UNITED STATES PATENT AND TRADEMARK OFFICE

10/573,180

Office Action Summary	Application No. 10/573,180	Applicant(s) TANAKA, TOMIJI	
	Examiner PHILLIP NGUYEN	Art Unit 2828

DETAILED ACTION

FIG. 1

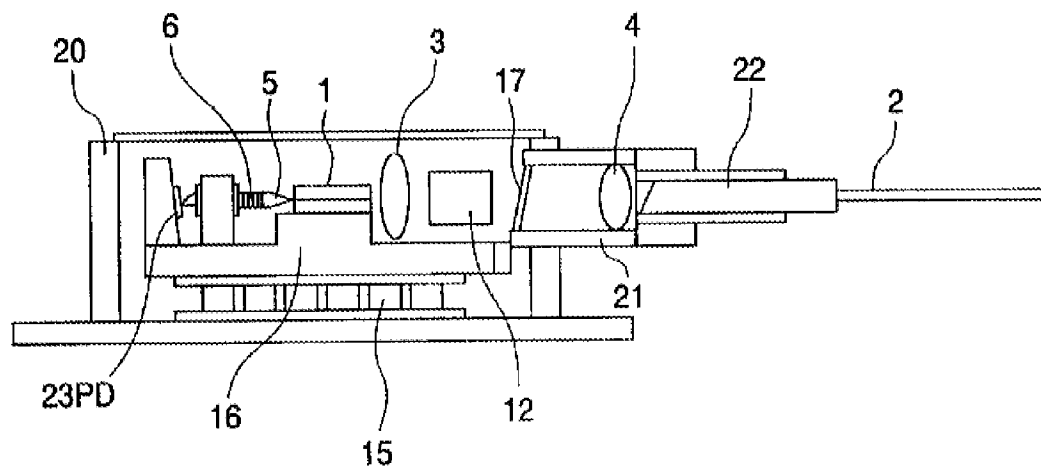
With respect to claims 1 and 11, Kimura discloses in Fig. 1a laser system, comprising: a base plate/surface plate 20; a heat sink (bottom plate of the enclosure); that is connected to the base plate and that is nearly perpendicular thereto; a heat generation device or a heat absorption device 15 that is connected to the heat sink and that is nearly perpendicular to the base plate; and a laser section that is connected to the heat generation device or the heat absorption device and that is nearly perpendicular to the base plate, one surface of the heat generation device or the heat absorption device being connected to the laser section, the other surface of the heat generation device or the heat absorption device being connected to the heat sink, wherein the laser section has a semiconductor laser device 1, a lens 5, a grating 6, and a support member 16, the semiconductor laser device, the lens, and the grating composing an external cavity type semiconductor laser, the support member supporting the external cavity type semiconductor laser, wherein the laser section is connected to the heat generation device or the heat absorption

device connected to the heat sink by the support member, and wherein the external cavity type semiconductor laser is covered by the support member and a lid 17 that has heat resistance.

With respect to claims 3 and 13, Kimura discloses a space between the laser section and the base plate with a predetermined height (see the Fig. 1).

With respect to claims 4, 7, 14 and 17, Kimura discloses the claimed invention except for explicitly teaching the specific distance between the base plate and the laser section; however, it would have been obvious to the one having ordinary skill in the art at the time the invention was made to provide a distance of at least 10 mm between the laser section and the base plate because the distance between the grating support and the base plate is obviously larger than 10 mm.

With respect to claims 5-6, 8, 15-16, and 18, there is air between the base plate and the photodiode holder. Air is considered as a good heat insulation member. Therefore the laser system include a space between the base plate and the laser section, because the photodiode holder is located between the base plate and the laser section.
